STAFF REPORT

CITY OF COLUMBUS PLAN COMMISSION (September 14, 2016 Meeting)

Docket No. / Project Title: PUDF-16-08 (Ricker's Gas Station)
Staff: Allie Keen

Applicant: Ricker's (Travis Smith)
Property Size: 2.00 Acres
Current Zoning: PUD (Westwood Planned Unit Development)
Location: Northeast corner of the State Road 46 and Westwood Boulevard intersection, in the City of Columbus

Store Canopy

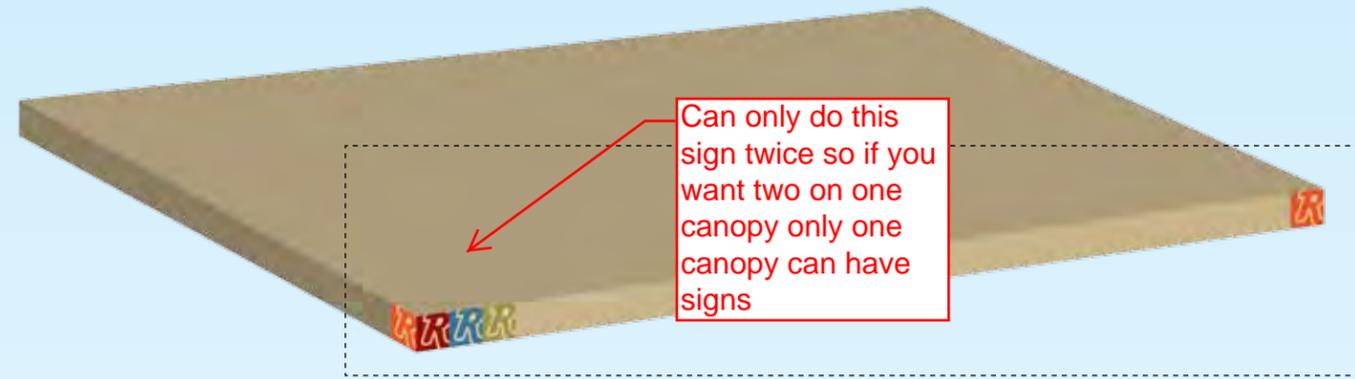
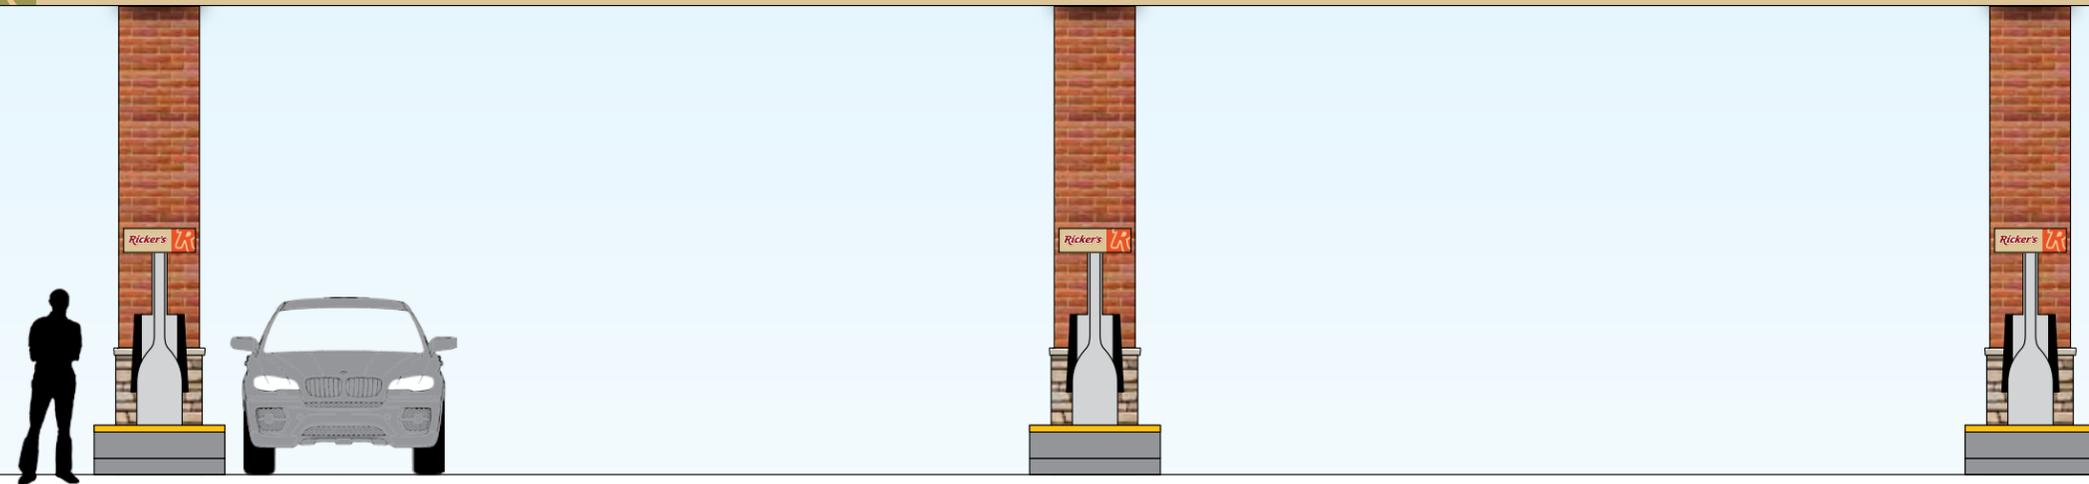
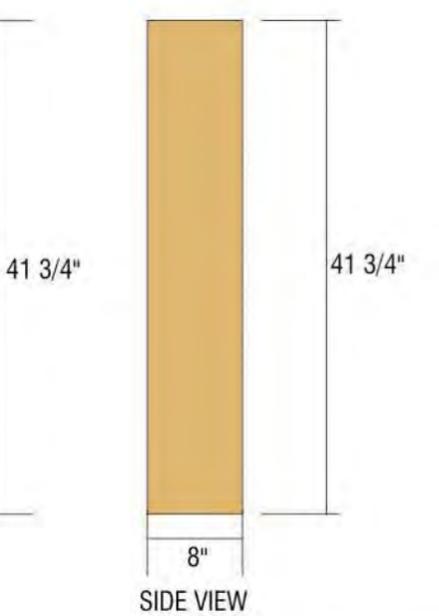
- d. Clarify on the sign plans whether or not there will be a gas price sign on the canopy as a part of the "R" signs. The drawings provided are not consistent.

SHEET NO.
C200
 PROJECT NO.
 W15.0161

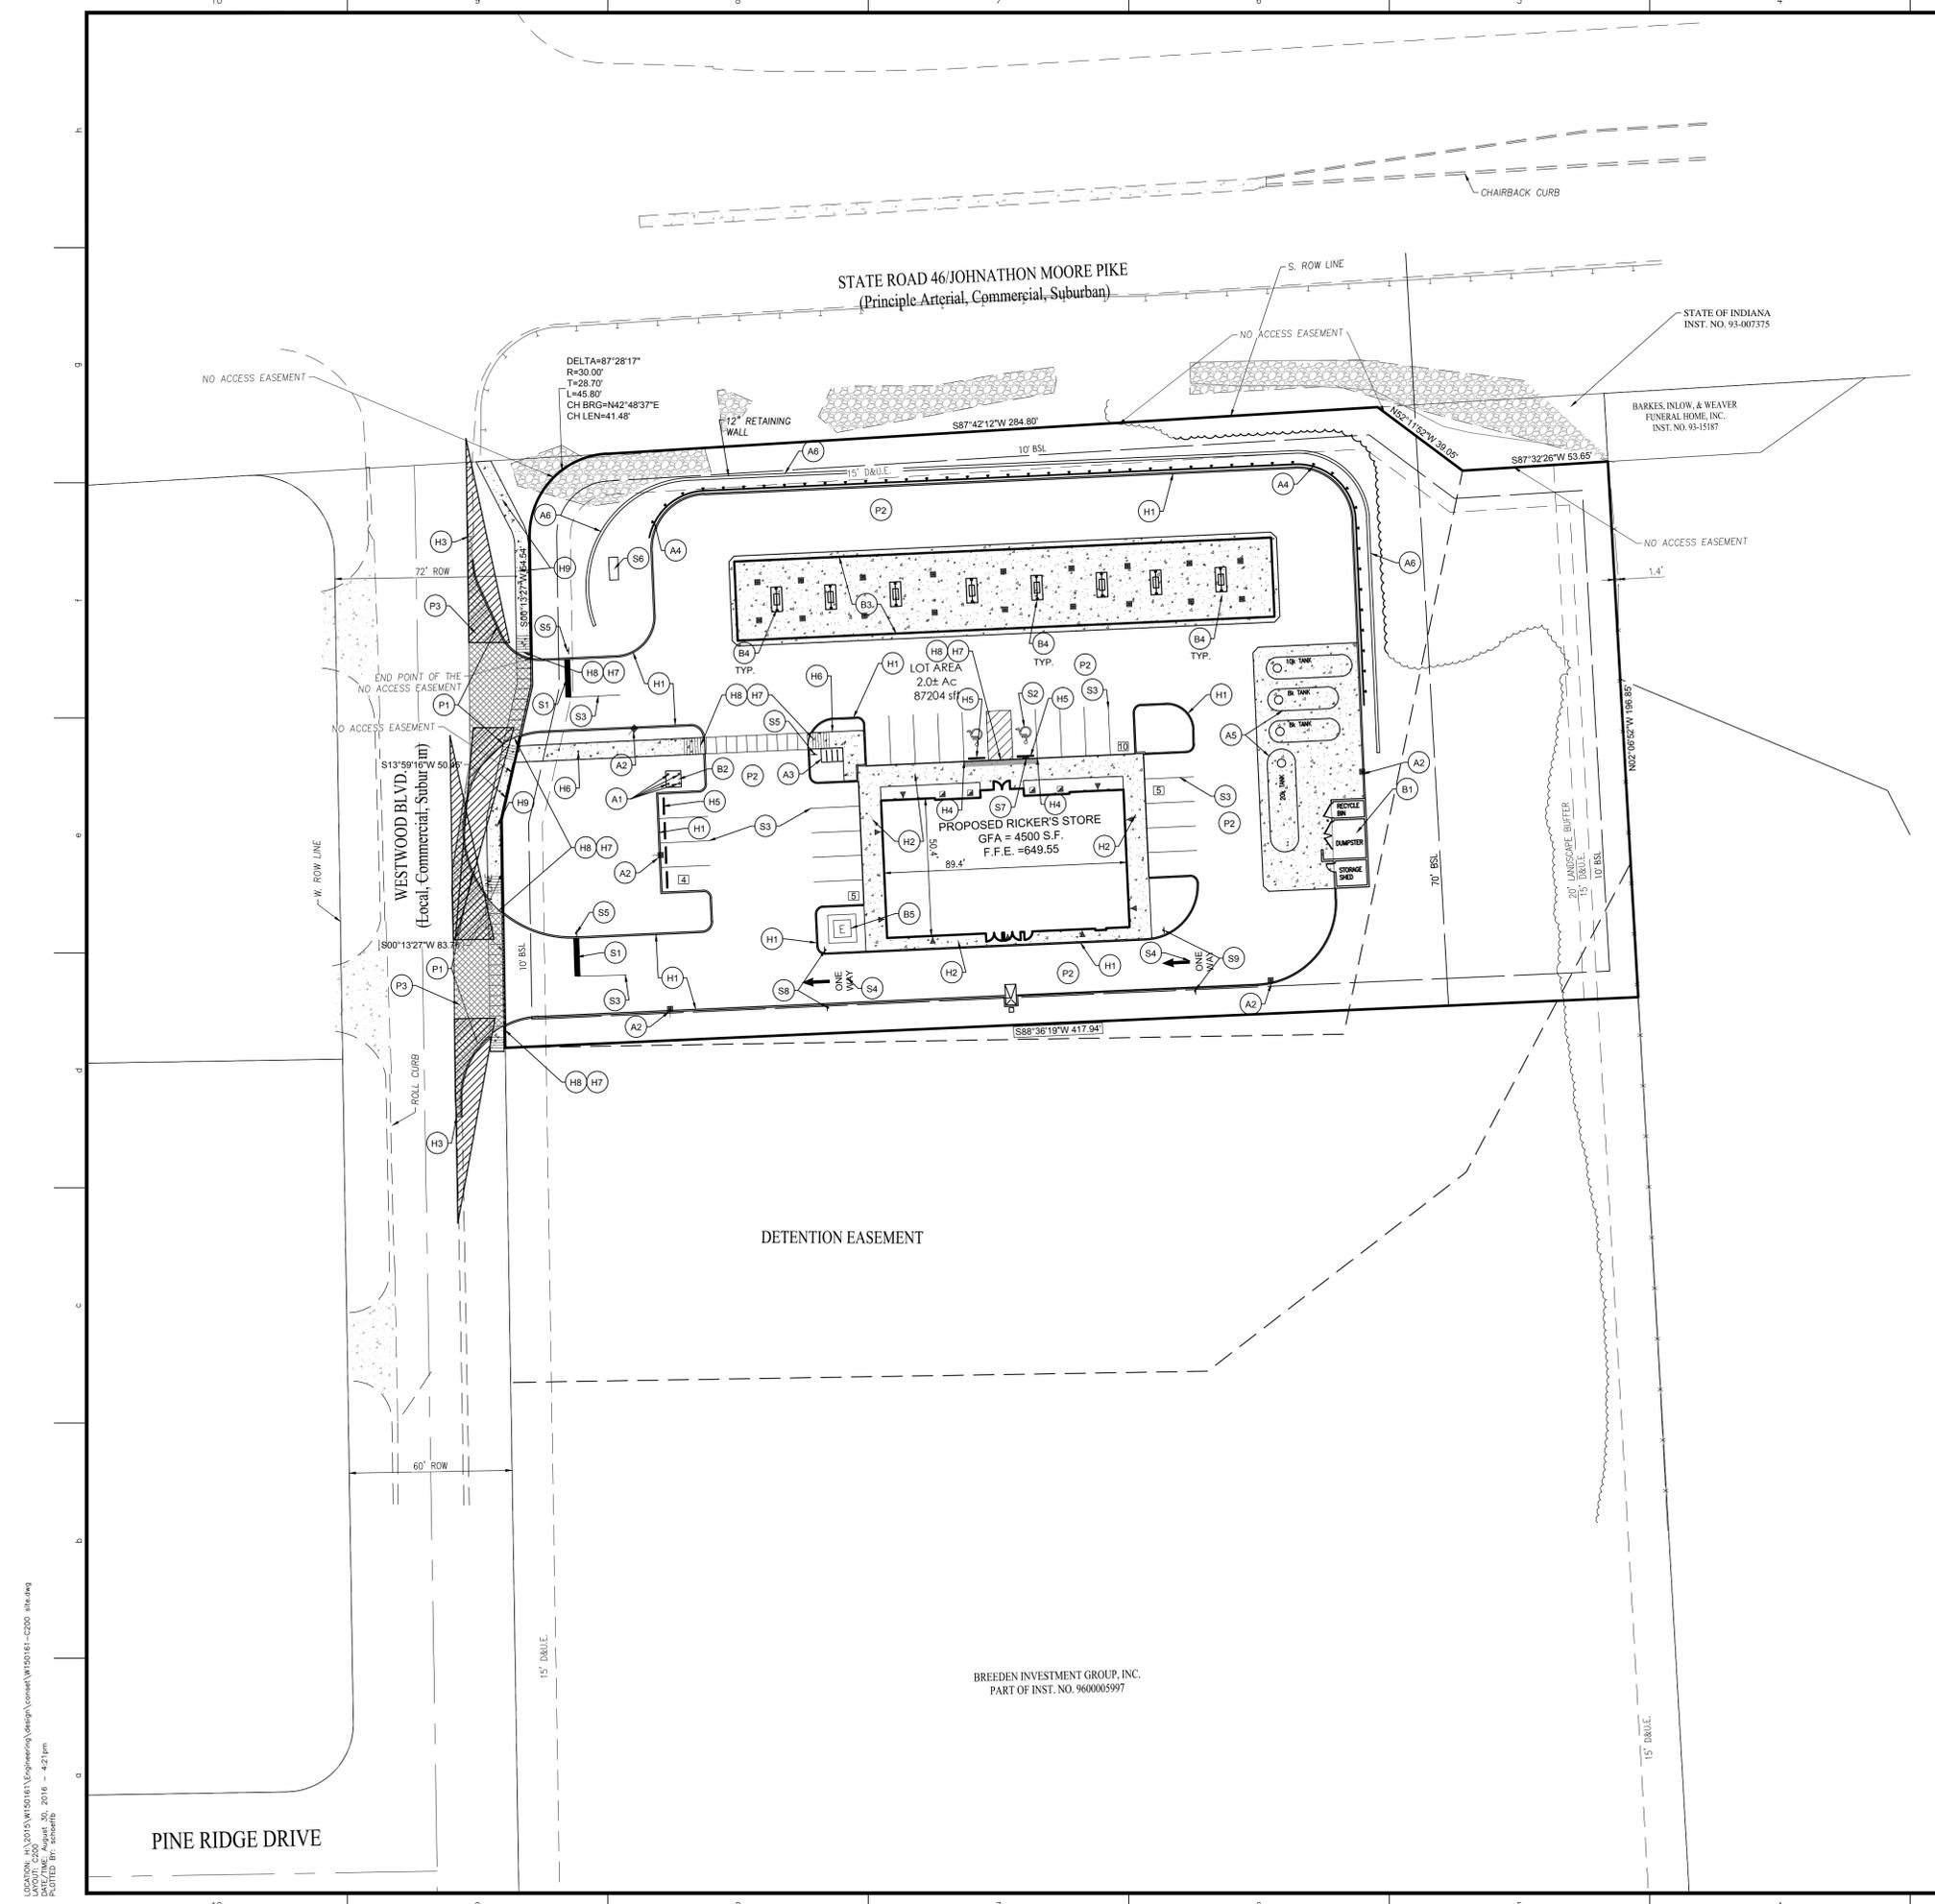
- b. The legal description is incorrect and should be "Lot 6 as shown on the plat of "Westwood 5th Replat" recorded in Plat Book R, Page 364B..."
 - c. Sheet C200, remove the "No Access" notation between the two driveways.

SHEET NO. **L100**
PROJECT NO. W15.0161

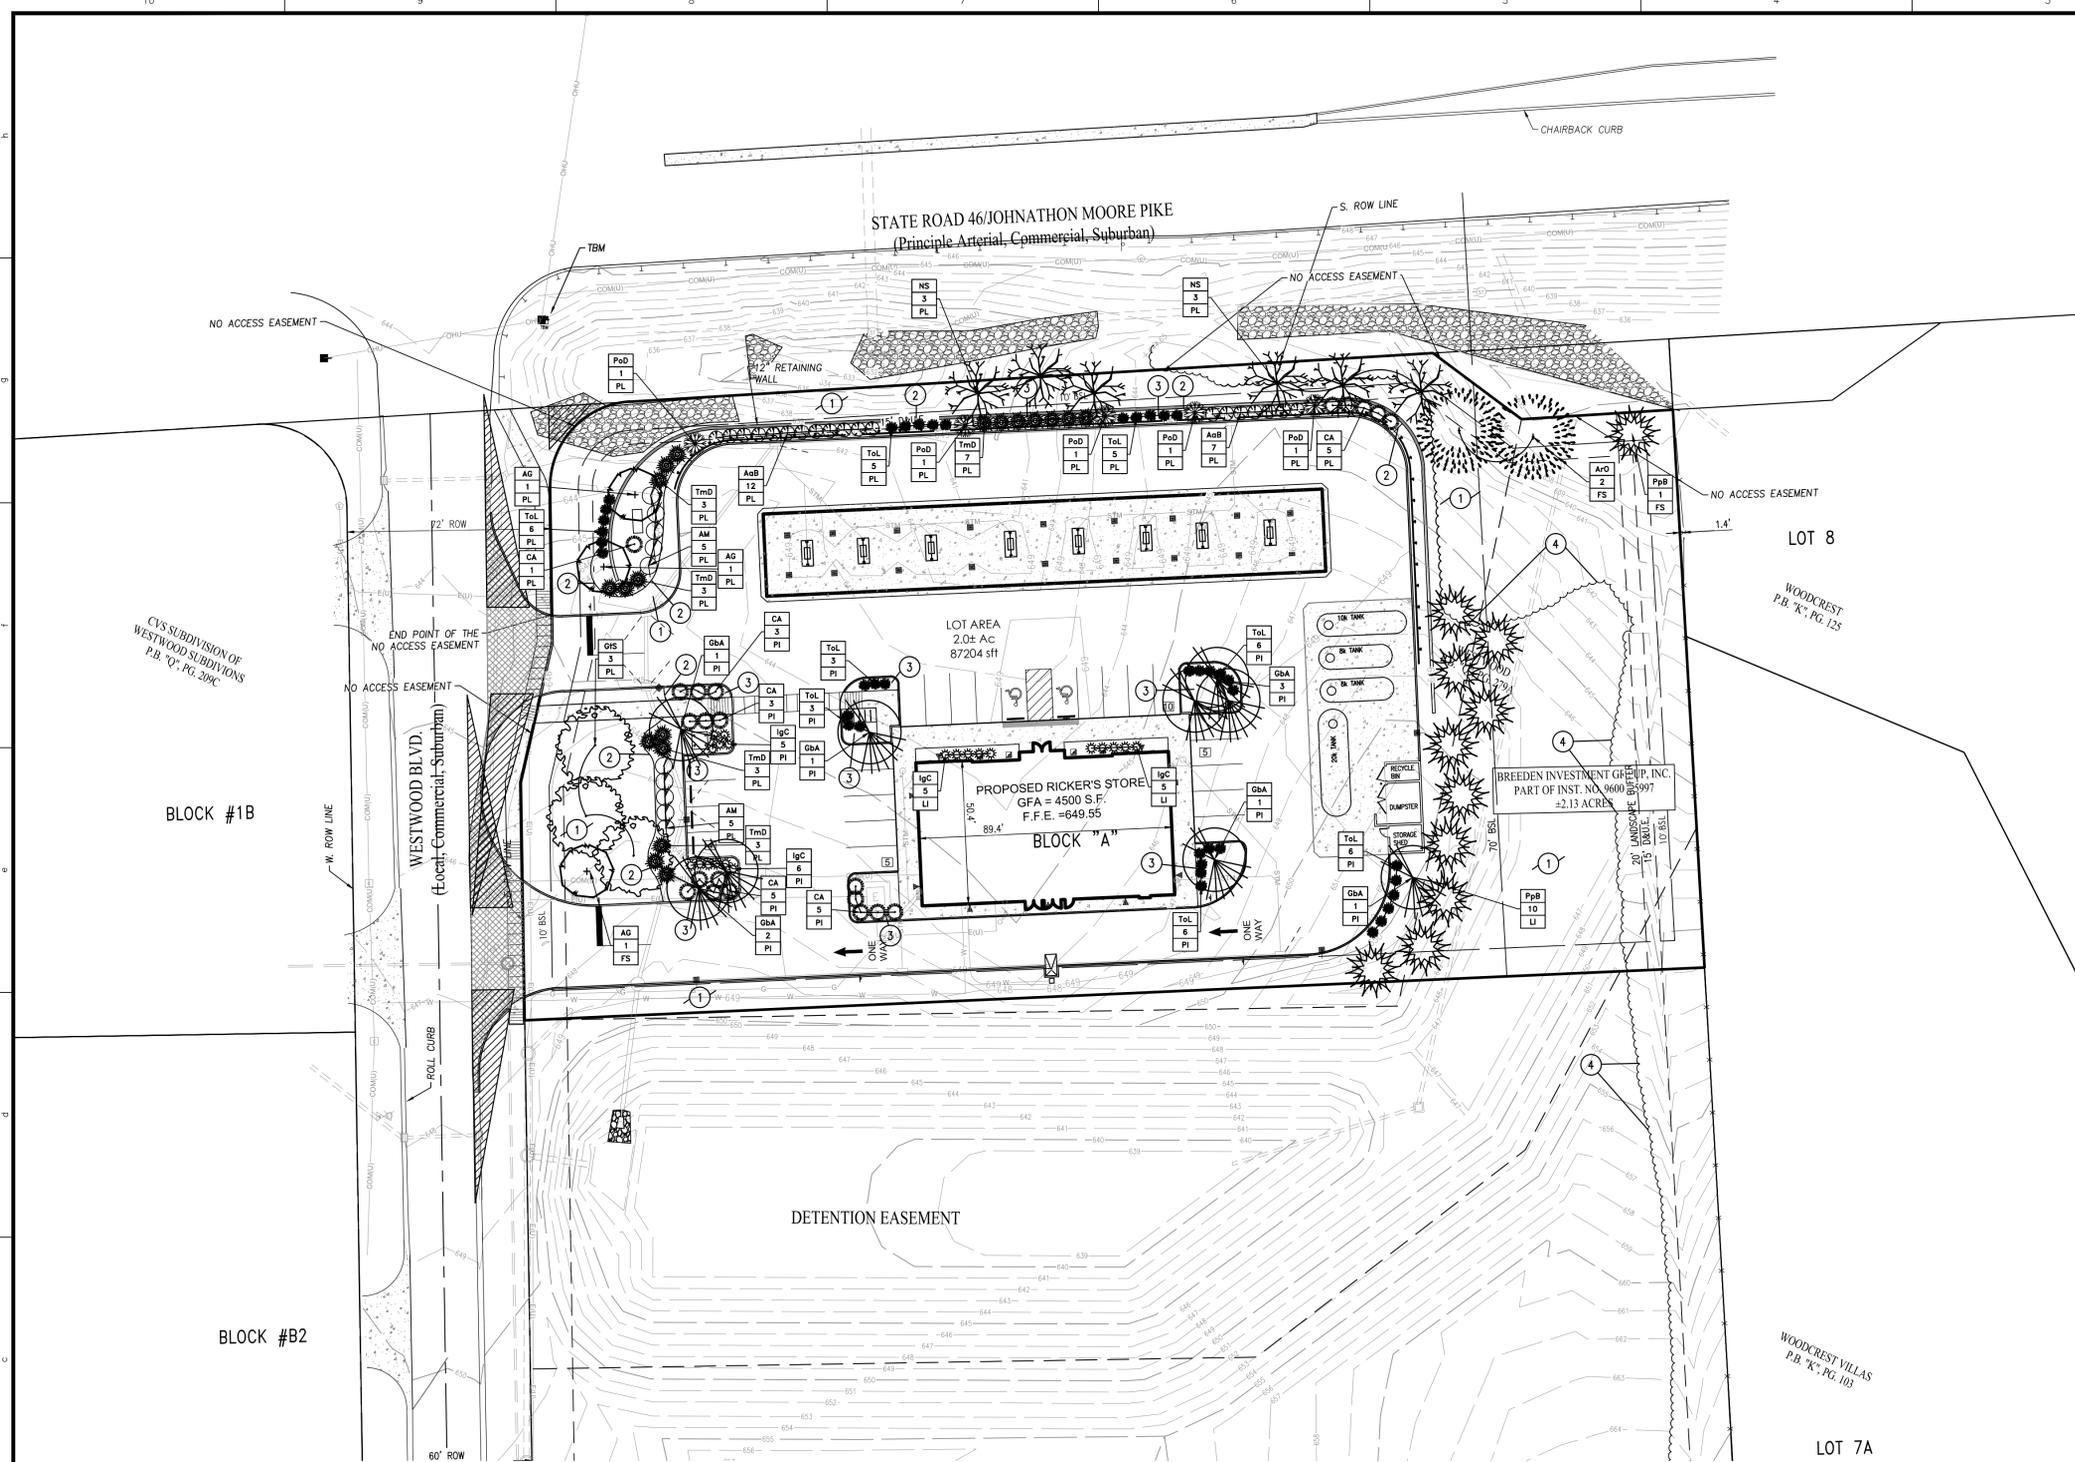
- f. The landscaping design at the northeast corner of the site shall be clarified. Per sheet L100 an area of “vegetation to remain” overlaps with new trees and sod.

4. The dwarf “Baby Blue Colorado Spruce” trees proposed to contribute to screening of adjoining residences to the east shall be replaced with large or medium evergreen trees.
